Re: Washington State Department of Ecology (Ecology) Assessment Report for Field Monitoring Activities conducted November 12, 2012 of the waste material near Riser 83 of the 241-AY-102 Double Shell Tank (DST)

ASSESSMENT REPORT

Project: 241-AY-102 Field Monitoring, Riser 83 Video

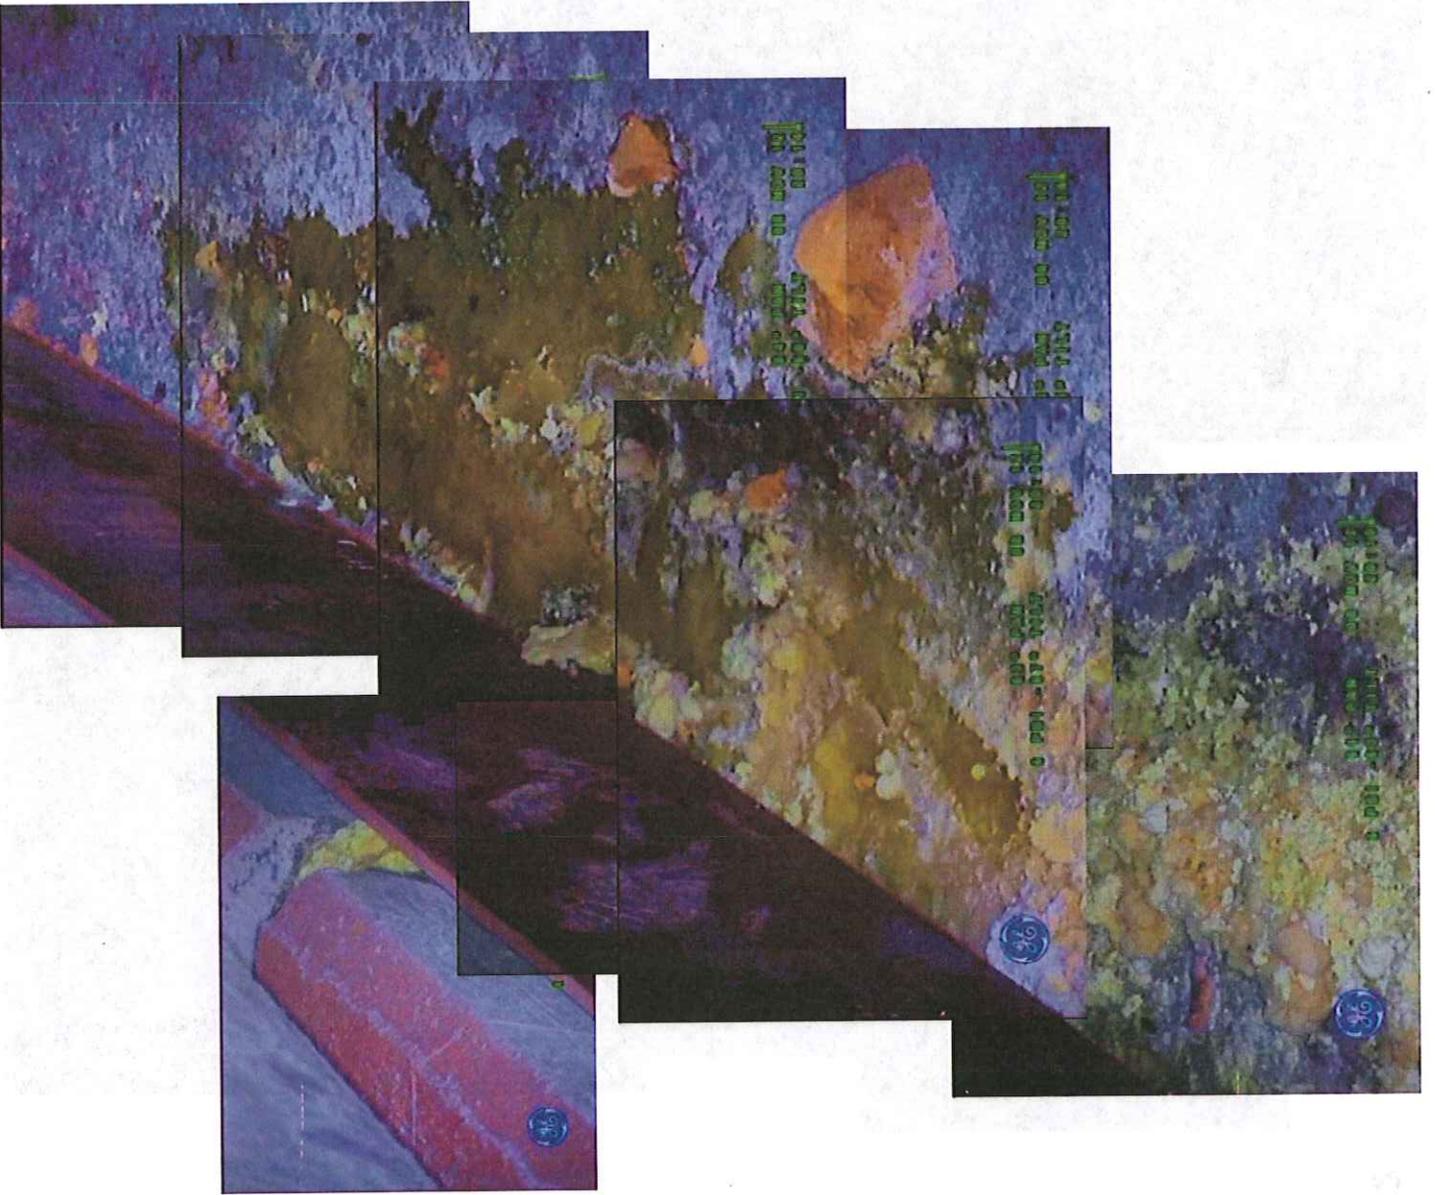
- The extent of the area of the waste material with respect to the annulus “landmarks” (orange foam pieces, black pebble, the ventilation slot, etc.) appeared to slightly grow as compared to the amount of material viewed during the visual inspection conducted 10/18/12 and 10/25/12.

- The moisture streaks on either side of the waste within the ventilation slot near Riser 83 once again appeared to be wet, indicating that the slow leak is still present and has not “self-healed”.

- An increased amount of white mineralization on the outside perimeter of the waste material within the annulus space.
- The waste material near the 6-inch refractory/connector ring had turned color from yellow to white. The size or height of the white waste material appeared to “grow” or crystalize. This increase in waste height, in turn created the appearance of “deeper” waste pools and finger channeling of the green and darker yellow colored waste.

had turned from yellow to white and appeared to "grow" in height or crystalize. And as this white waste material appears to increase in height, the finger channels of waste or pools of waste (that are dark green, light green, and yellow) appear to look deeper and slightly extend in length.
